## ADDENDUM NO. 2

### San Antonio Water System

Project Name: **LIFT STATIONS REHABILITATION – PHASE 2**

Project No.: **06-2503**

SHEET NO. **E-148-1**  
036 OF 246

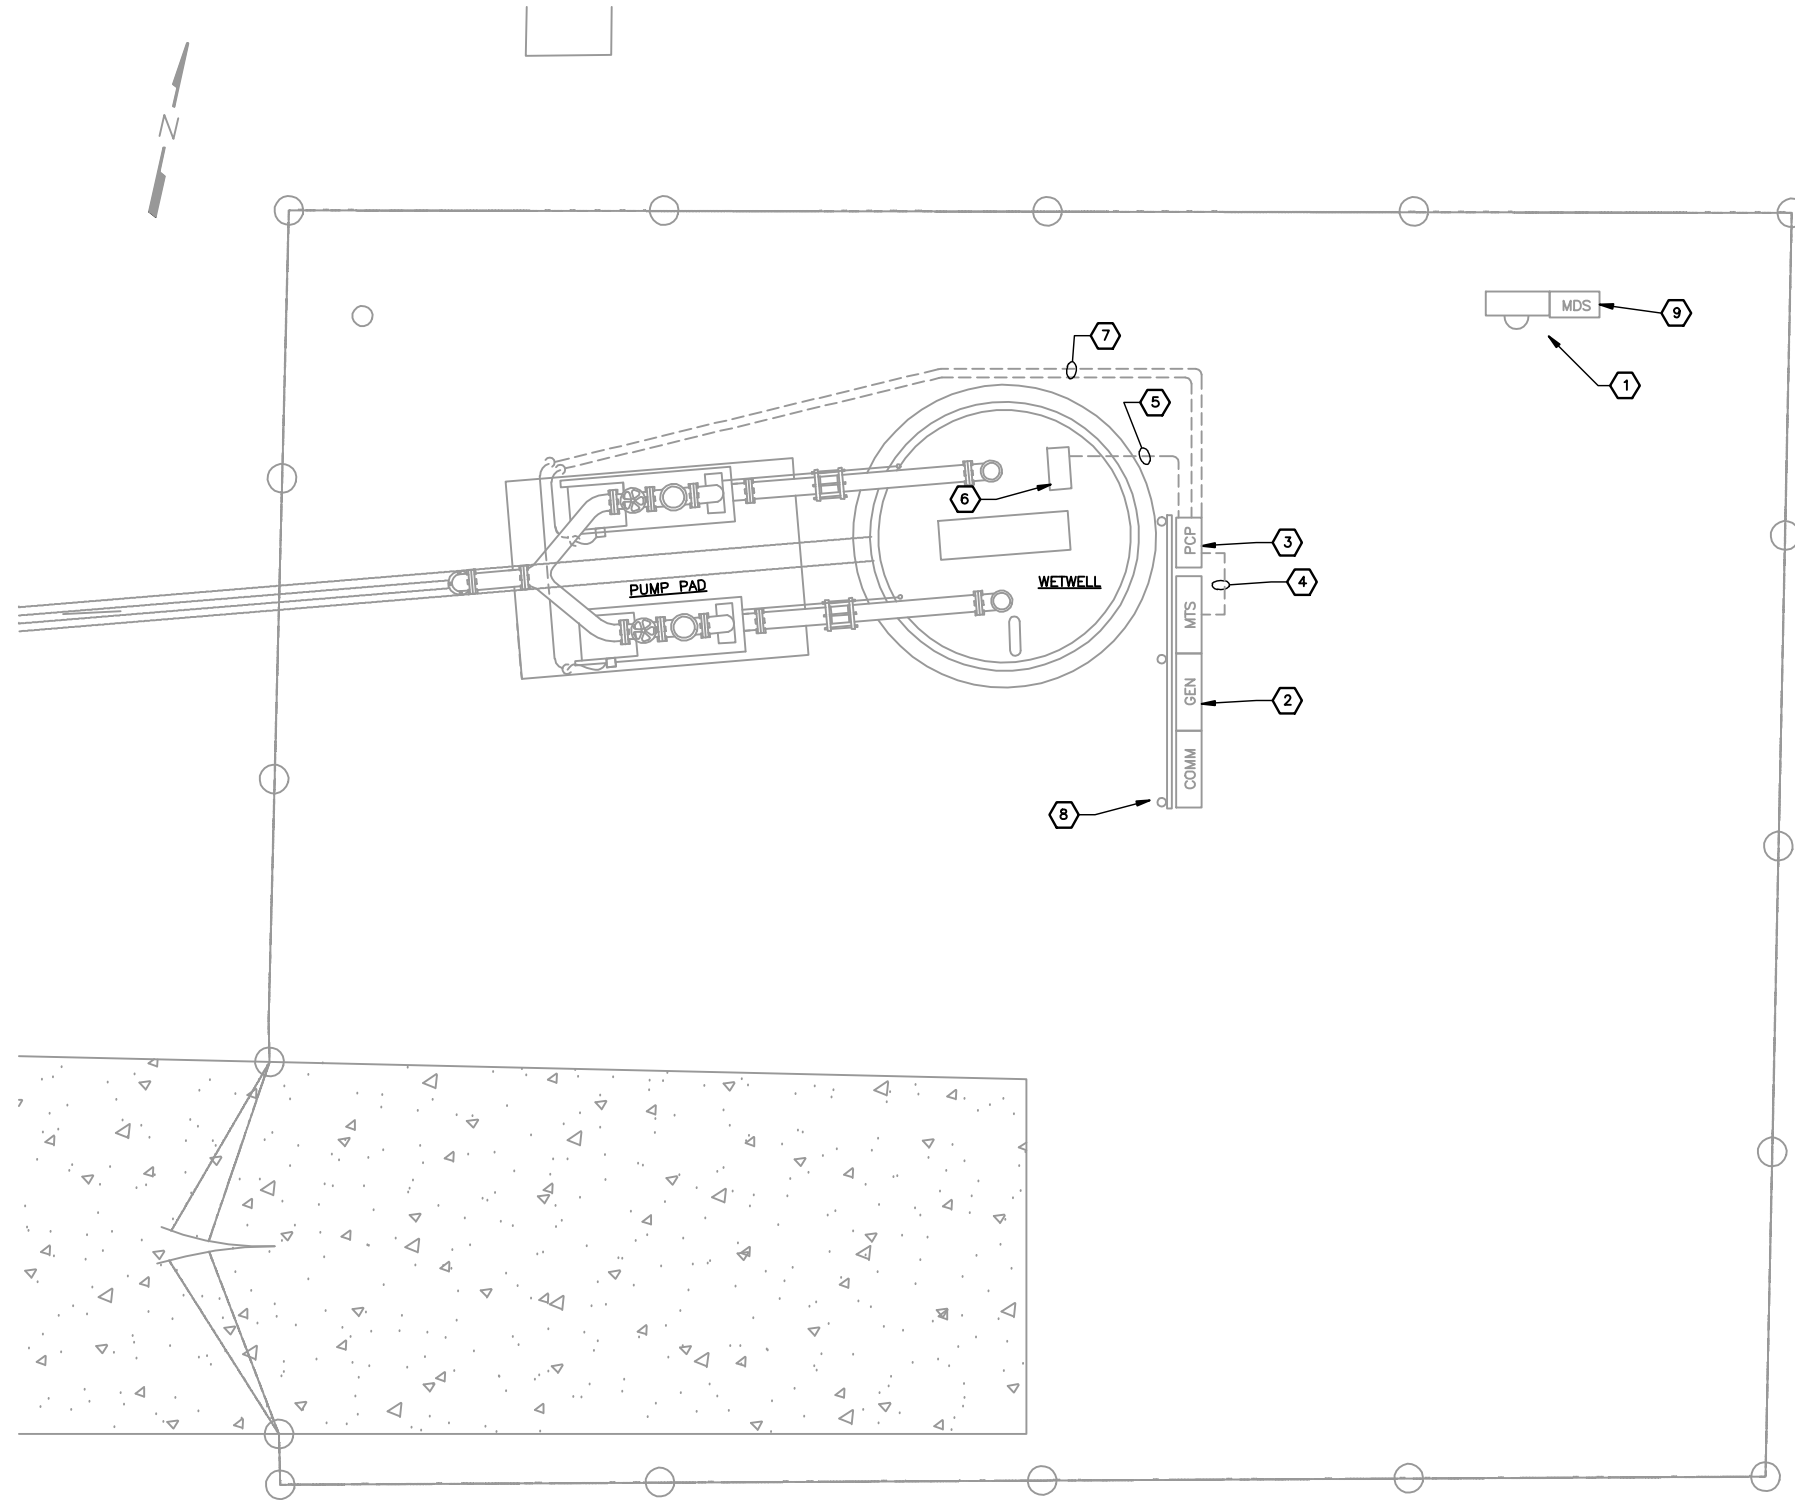
### **Item 1: LS# 148: Electrical Site Plan and One Line Diagram**

- a) Clarification: New 480/277V, 3 $\phi$ , 4W is not required. Existing 120/240V, 1 $\phi$ , 3W to remain. Rotary phase converter shall be installed.
- b) DELETE Sheet E-148-1, Sheet 036 of 246 and REPLACE with attached revised sheet dated 10/21/2010.
- c) DELETE Sheet E-148-2, Sheet 037 of 246 and REPLACE with attached revised sheet dated 10/21/2010.
- d) DELETE Sheet E-148-3, Sheet 038 of 246 and REPLACE with attached revised sheet dated 10/21/2010.

SCALE: AS SHOWN
SHEET NO. <b>E-206-1</b>
103 OF 246

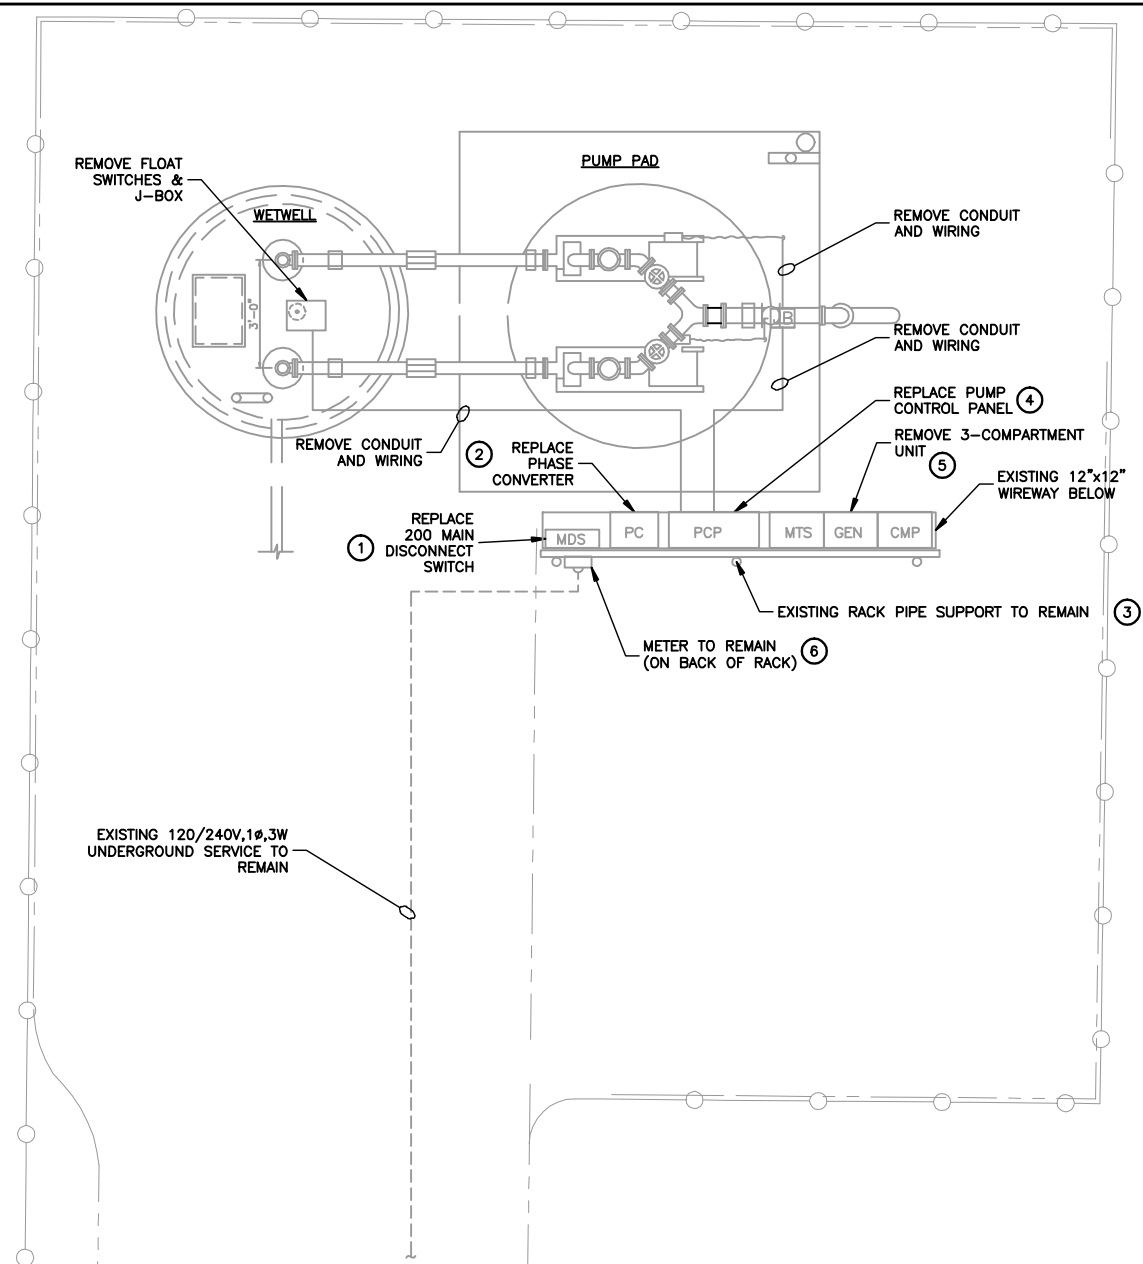
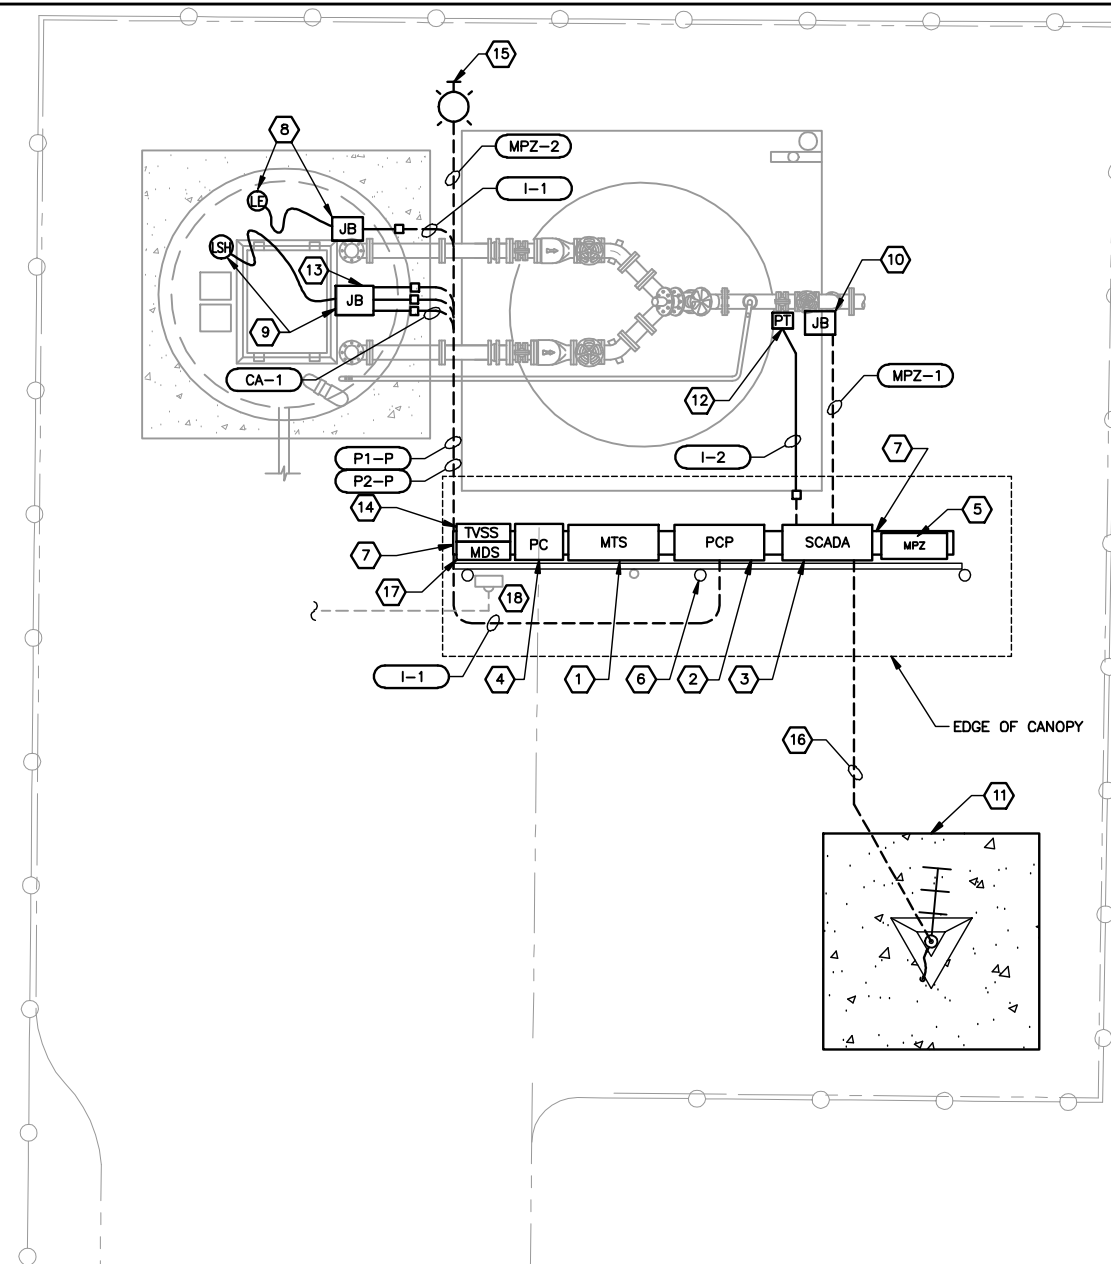
### **Item 2: LS# 206: Electrical Site Plan and One Line Diagram**

- a) Clarification: New 480/277V, 3 $\phi$ , 4W is not required. Existing 120/240V, 1 $\phi$ , 3W to remain. Rotary phase converter shall be installed.
- b) DELETE Sheet E-206-1, Sheet 103 of 246 and REPLACE with attached revised sheet dated 10/21/2010.
- c) DELETE Sheet E-206-2, Sheet 104 of 246 and REPLACE with attached revised sheet dated 10/21/2010.

NOTES	INITIALS	DATE
DESIGNED BY	BLH	9/17/2010
REVIEWED BY	JRS	9/17/2010
SCALE: AS SHOWN		
SHEET NO.	E-223-1 134 OF 246

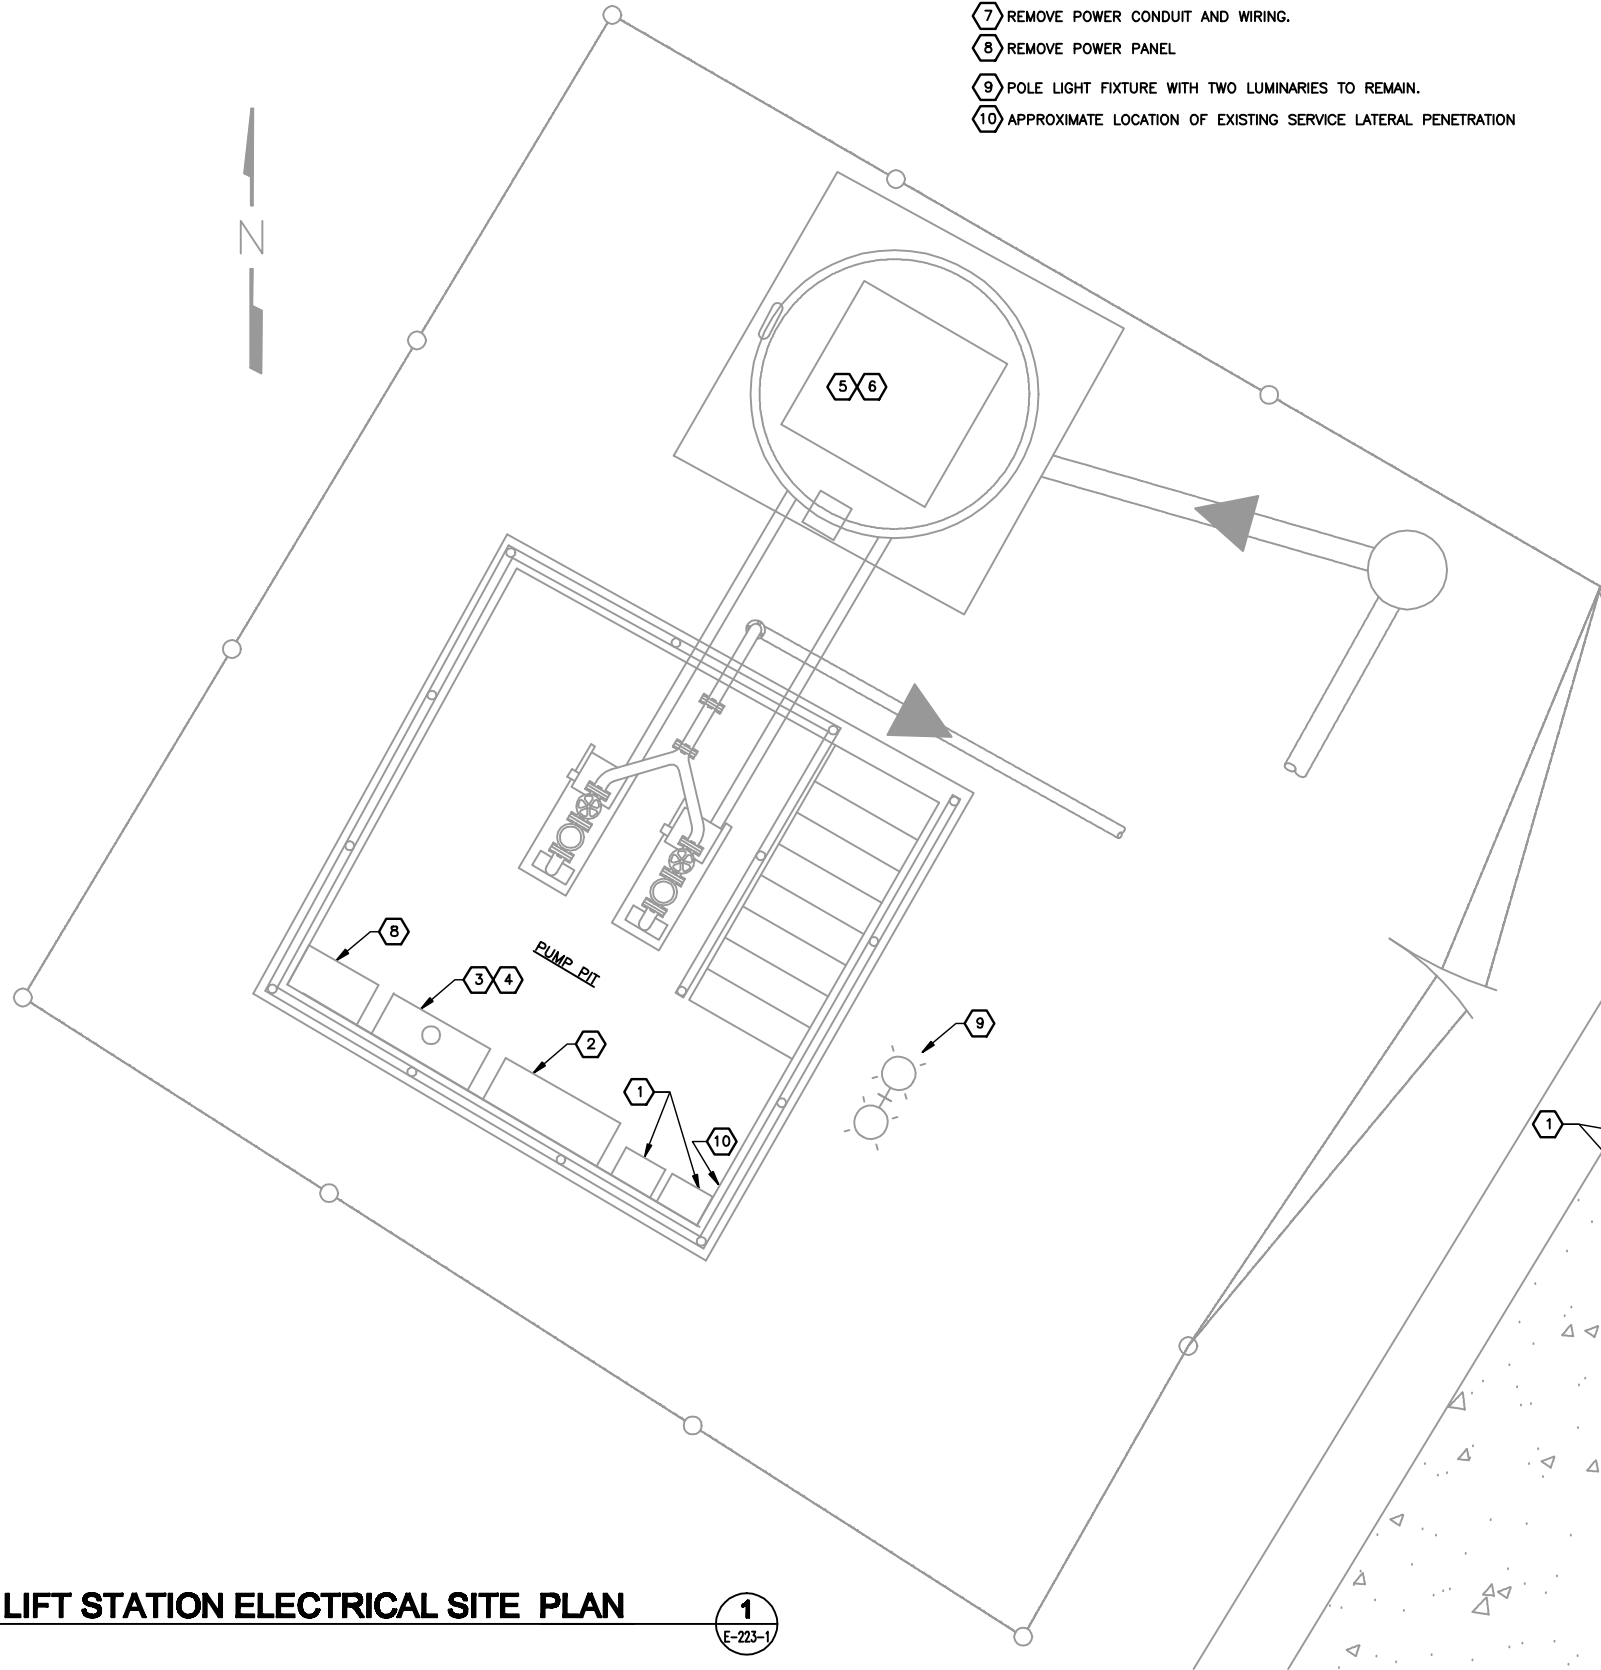
### **Item 3: LS# 223: Electrical Site Plan and One Line Diagram**

- a) Clarification: Drawing has been revised for combined Soft Start-PCP cabinet location and other electrical revisions, including service voltage change.
- b) DELETE Sheet E-223-1, Sheet 134 of 246 and REPLACE with attached revised sheet dated 10/21/2010.
- c) DELETE Sheet E-223-2, Sheet 135 of 246 and REPLACE with attached revised sheet dated 10/21/2010.
- d) DELETE Sheet E-223-3, Sheet 136 of 246 and REPLACE with attached revised sheet dated 10/21/2010.
- e) DELETE Sheet E-223-4, Sheet 137 of 246 and REPLACE with attached revised sheet dated 10/21/2010.
- f) DELETE Sheet E-223-8, Sheet 141 of 246 and REPLACE with attached revised sheet dated 10/21/2010.
